**International Competition of Overall Conceptual Planning
and Landscape Design for Blueways around Xili Reservoir**

答疑文件

Clarification Document

Tenderee: Water Authority of Nanshan District, Shenzhen

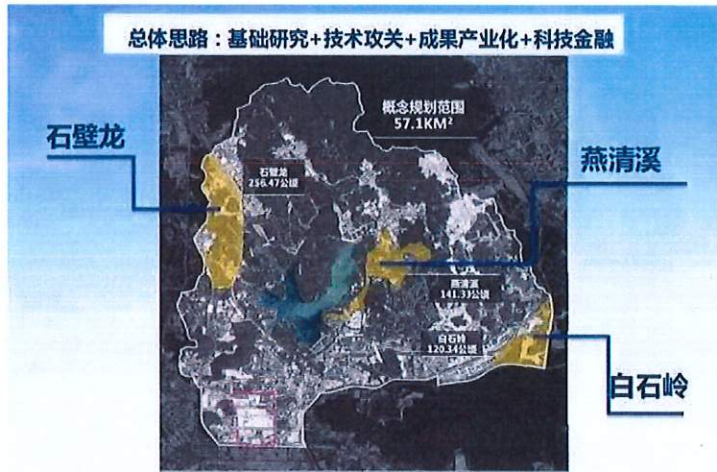
5. 西丽湖国际科教城的总体规划、空间规划、产业规划和配套规划能否提供？
5. Could you provide the master plan, spatial planning, industry planning and supporting facilities planning of Xili Lake International Science and Education City?

目前，西丽湖国际科教城已经形成1个总体规划、空间规划、产业规划、配套规划3个。

经过两年年的调研论证，《西丽湖国际科教城空间规划纲要》基本确定了以西丽湖为心；依托沙河西路的南北轴，依托留仙大道的东西轴；大学城创新片区，石壁龙创新片区，西丽中心区的“一心、两轴、三区”的城市整体空间布局。

重点发展大学城、留仙洞、石壁龙、燕清溪、白石岭、西丽高铁枢纽等空间载体，在国家高新区扩区方案中，将留仙洞、石壁龙、大学城三个区域纳入国家高新区范围，基本覆盖了西丽湖国际科教城。高新区战略的布局，也为未来科教城的高新产业的发展提供了更大的机

答：暂无法提供。

A: Not available for now.
